ATTACHMENT A

Responses to NRC Questions on Pilgrim I Reload 2
Licensing Submittal (NEDO-20855-01)

ATTACHMENT B

Responses to NRC Questions on Pilgrim
Single Loop Operation (NEDO-20999)

Figure 3-1 PILCHIM 1990W4T/FULL COIL FLOW, LOSS OF 100 DEGREE FWH HEATER.

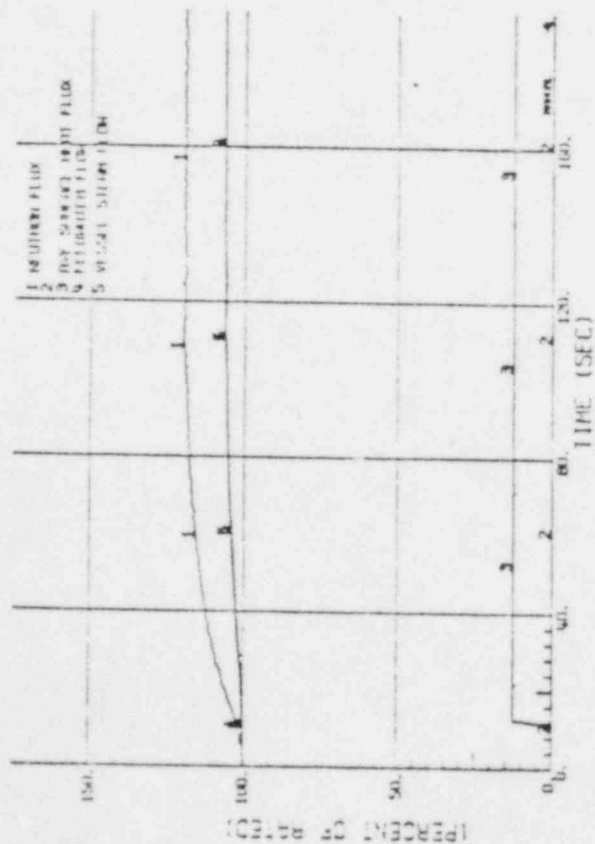
Question A3: Does a reactor scram occur as the result of a feedwater transient?

Response: In Paragraph 7.3.3.1.6.1 (Page 7-18) of NEDO-20855-01, the peak neutron flux was incorrectly stated as 120% of initial. The corrected statement should be: "Neutron flux increases to a value of 119.8% of initial at 109 seconds." Since the indicated neutron flux does not exceed the scram setpoint of 120%, scram does not occur. A time plot of the transient is shown in Figure 3-1 (attached).

Figure 5-1. Pilgrim Unit 1 Cycle 3, Power/Flow Map with Derated Boundaries

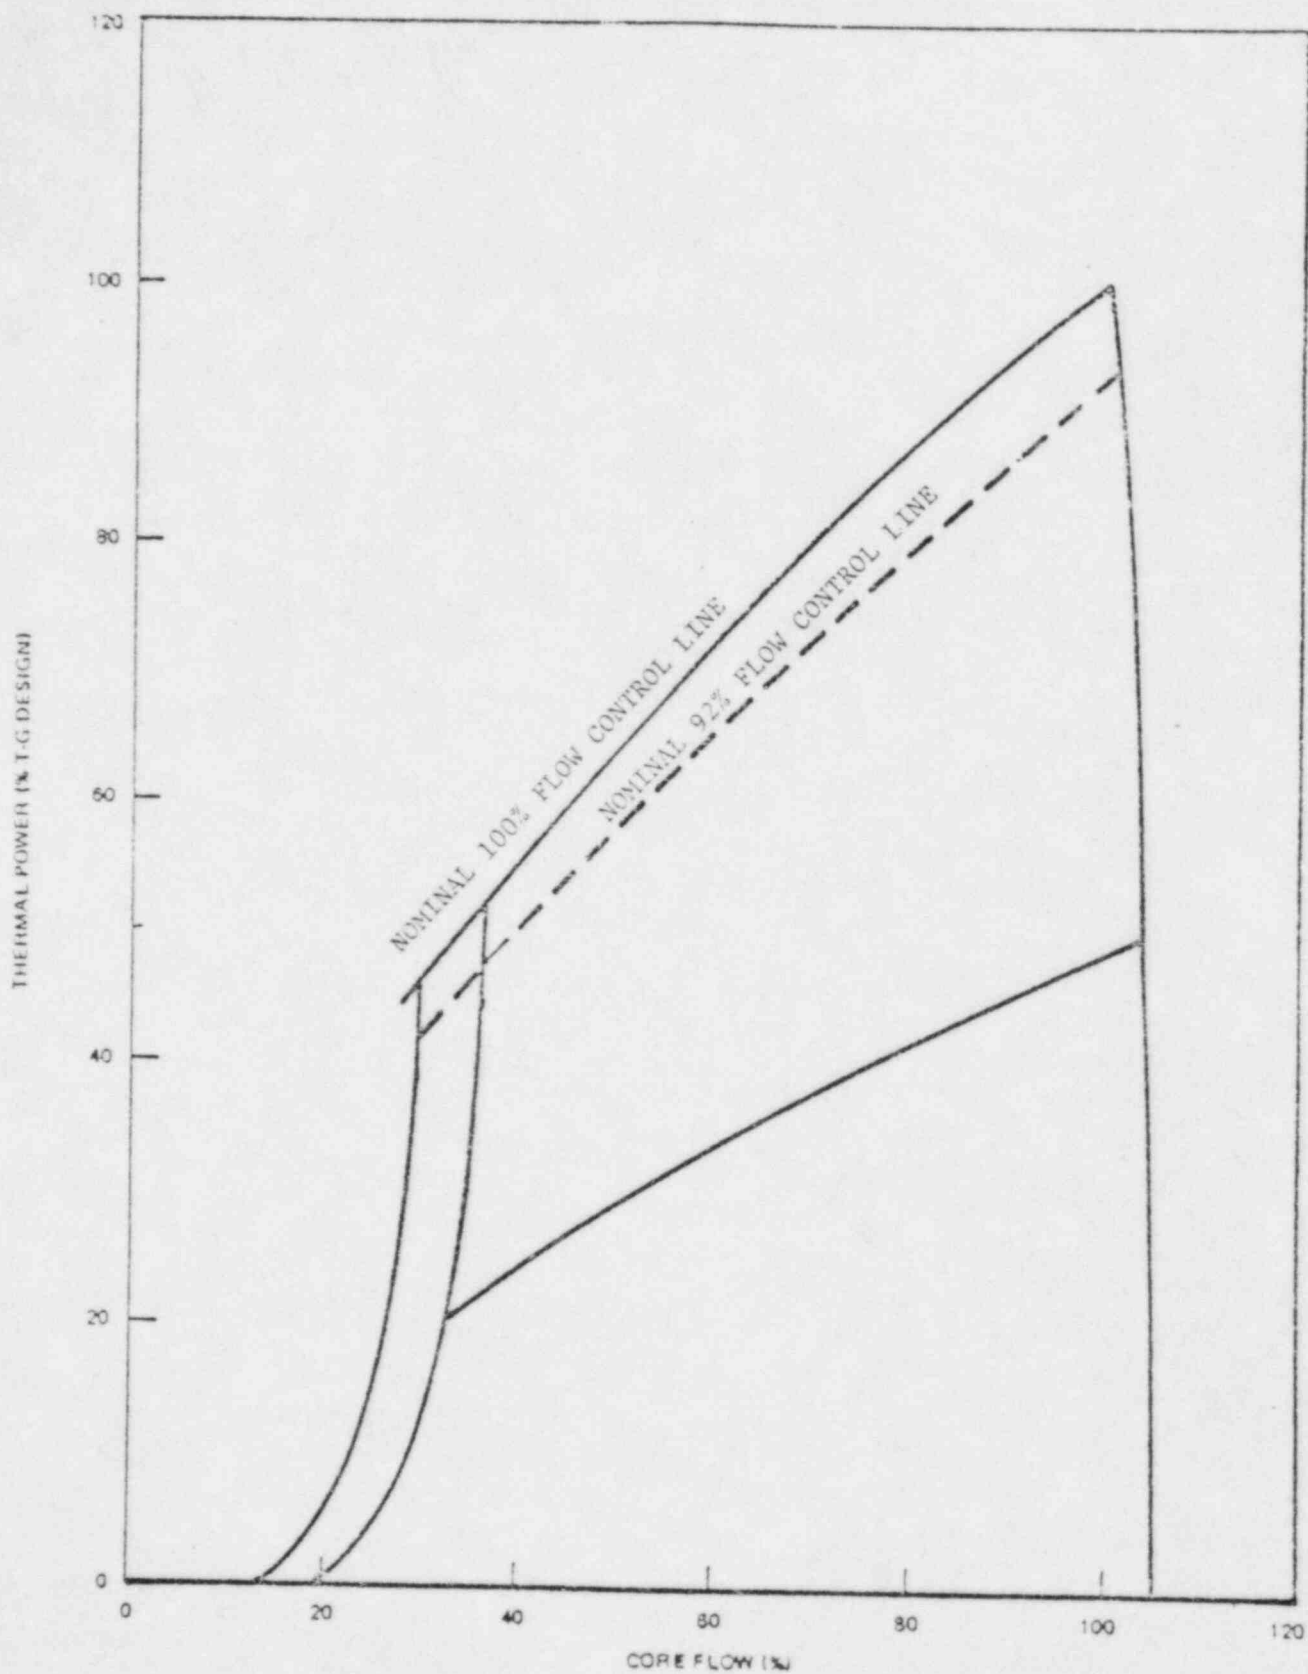
Question A4: Provide a power-flow map for Reload 2 showing a 92% power limit.

Response: The Pilgrim Cycle 3 power/flow map with the nominal 92% flow control line is shown in Figure 5-1, attached. Refer to response to Question A10 for a description of how Pilgrim 1 will operate on the power/flow map to achieve the 92% power, 100% flow endpoint at EOC-3.

FIGURE 4-1
PEAK CLADDING TEMPERATURE FOLLOWING A
DBA FROM SINGLE LOOP OPERATION FOR EXAMPLE
PLANT

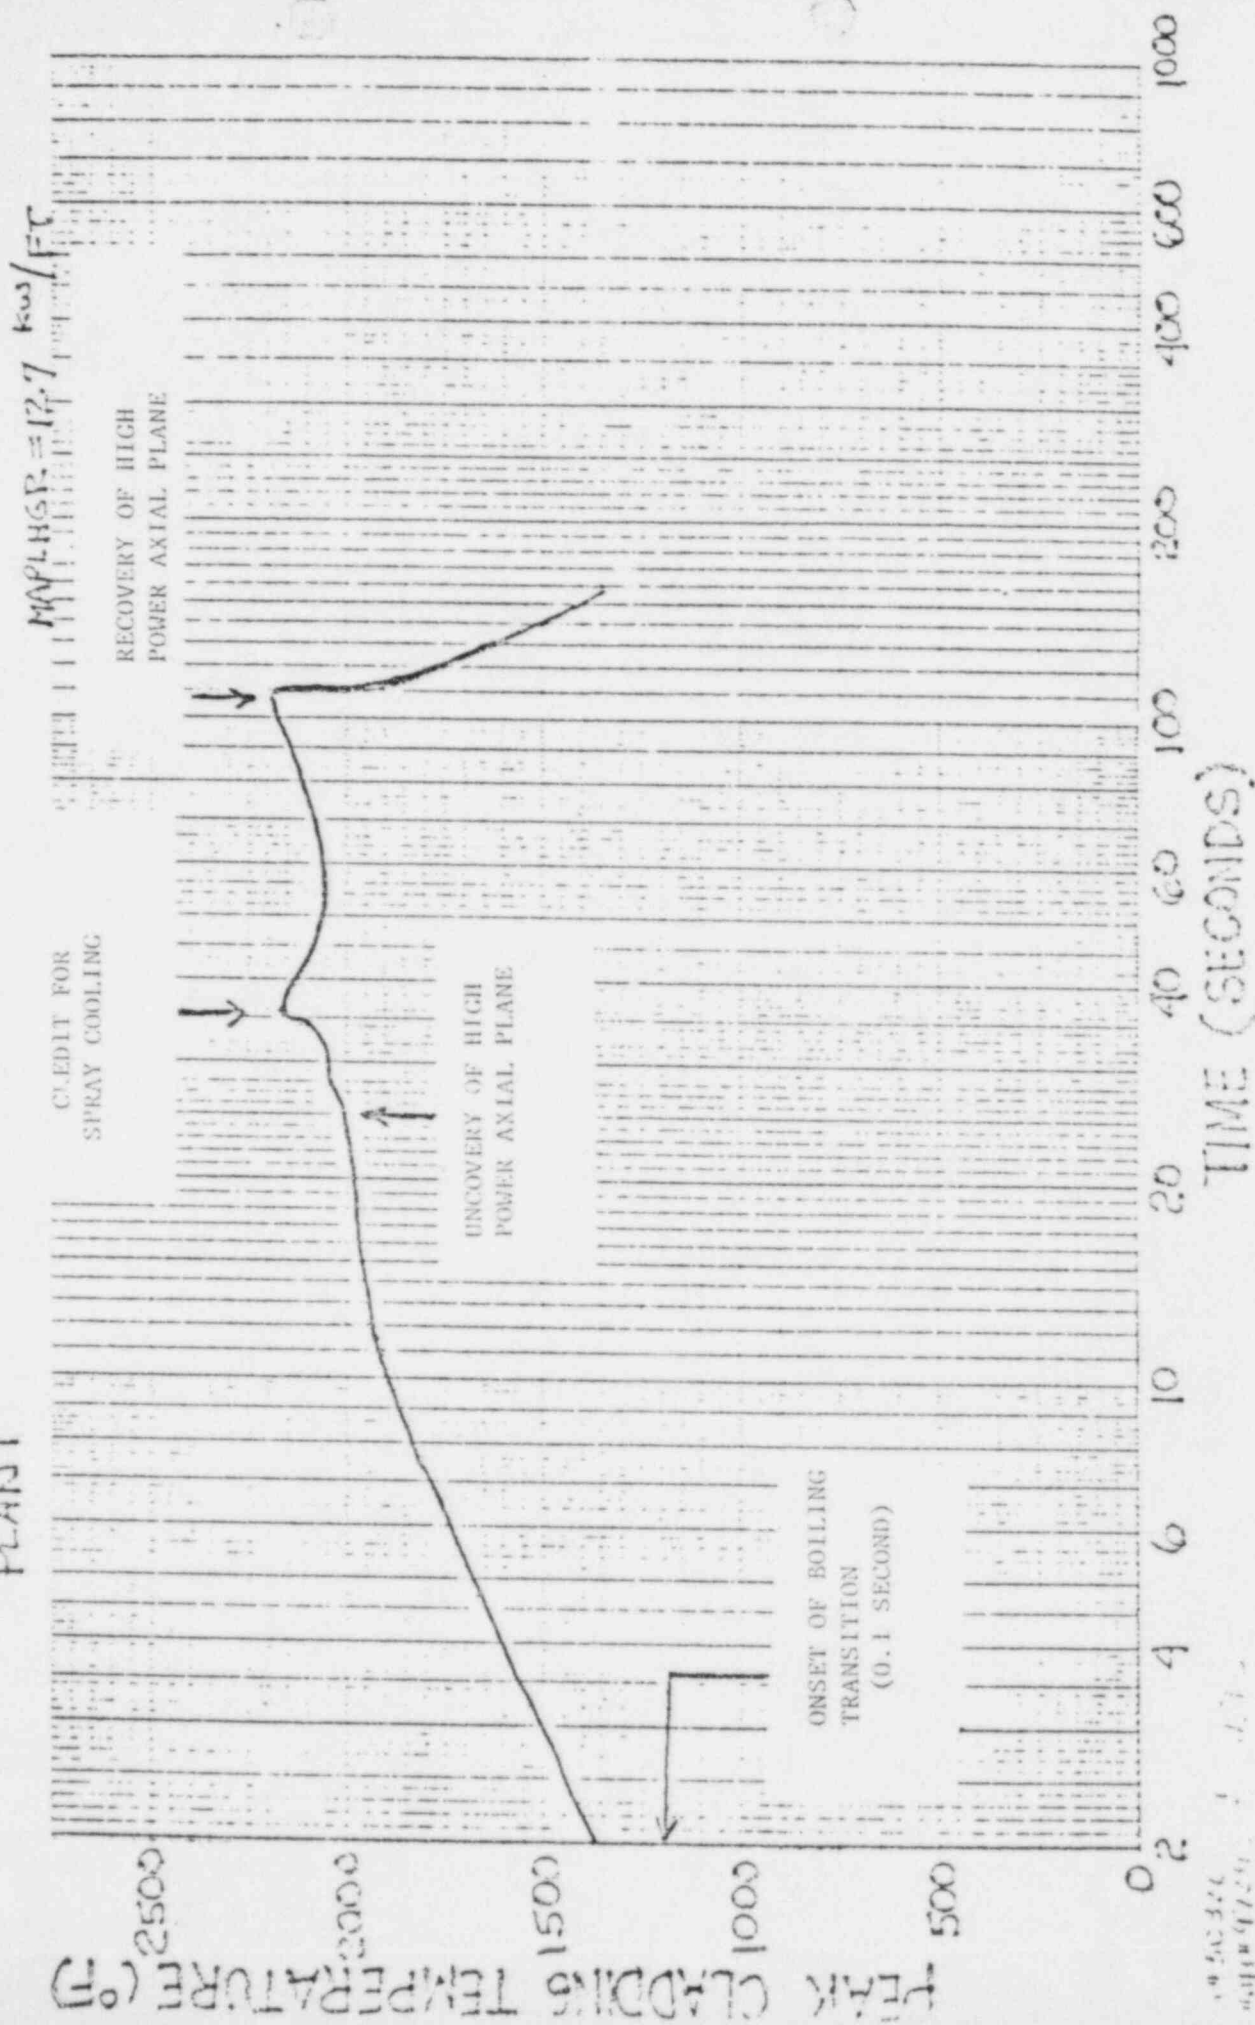
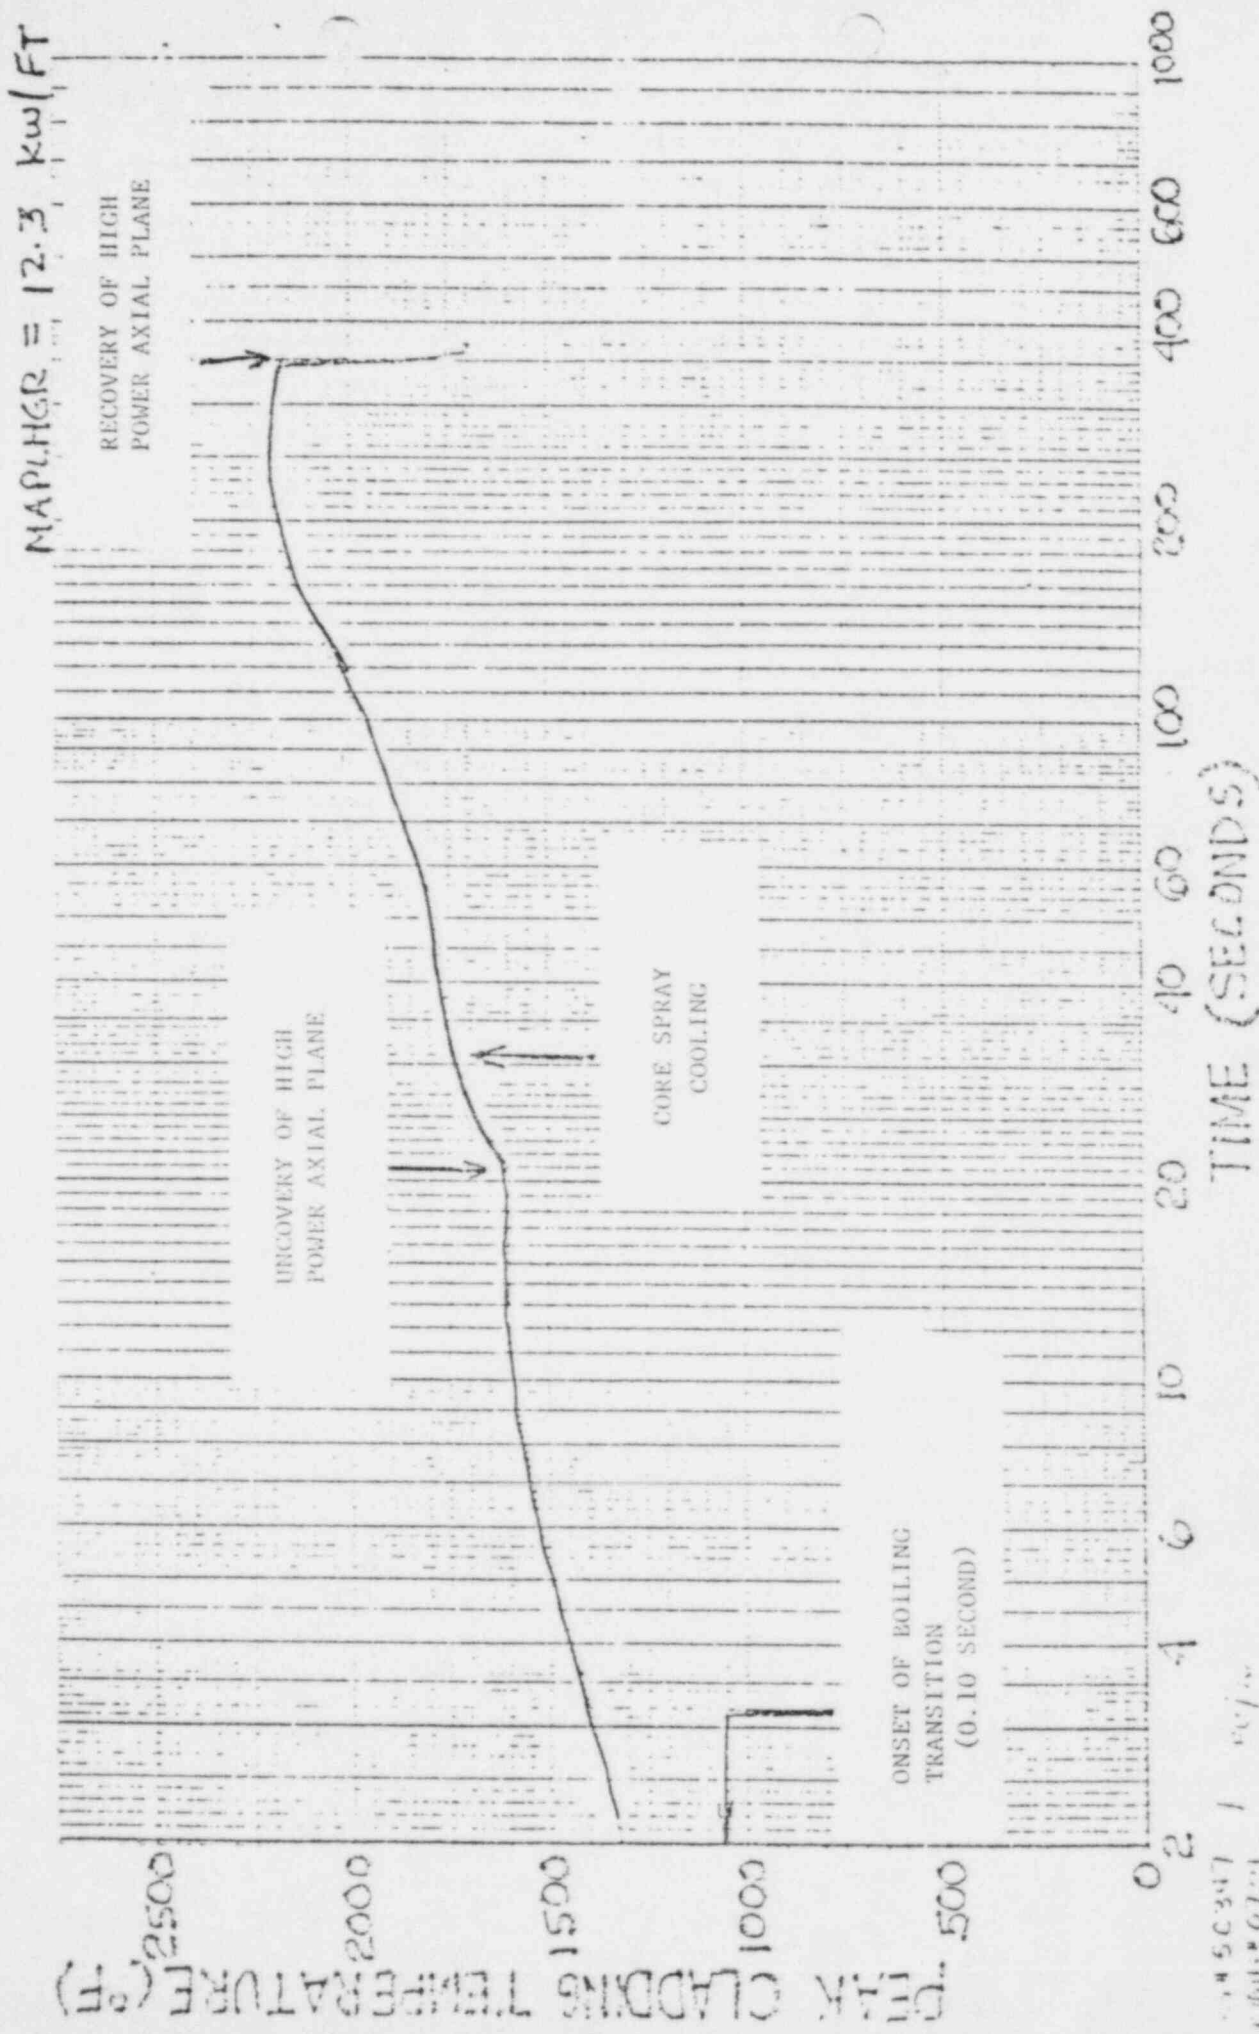
Question B4: Provide a curve of transient PCT of the lowest axial plain to experience CPR = 1.0 prior to jet pump uncover versus time with one pump operation.

Response: The cladding heatup analysis of the LOCA from one pump operation assumes that boiling transition occurs over the entire length of the fuel bundle at 0.1 seconds after the LOCA. In other words, all axial planes are assumed to experience CPR = 1.0 prior to jet pump uncover. Therefore, the high-power axial plane experiences the most severe cladding heatup. Plots of calculated peak cladding temperature versus time for the high-power axial plane are provided in Figures 4-1 and 4-2 for early and late reflooding BWR/4 plants.
